COMMITTEE OF THE WHOLE NOVEMBER 4, 2002

SIGN VARIANCE APPLICATION

FILE NO.: SV.02-025

LOCATION: 7850 WESTON ROAD, LOT/BLOCK 6, CONCESSION 6

1. Sketch of Sign

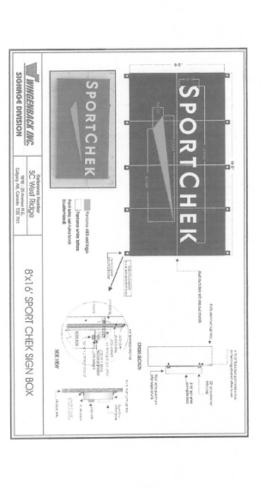
Applicant is requesting to install one (1) fascia sign on the south elevation that is slightly above the roof line.

This sign and sign location was shown on the site plan agreement below the roof line, however the applicant is requesting that it be above the roof line.

That Sign Variance Application SV.02-025, First Professional Management, be REFUSED.

5.8 Roof signs and signs erected in part or entirely above the surface of the roof of a building or structure.
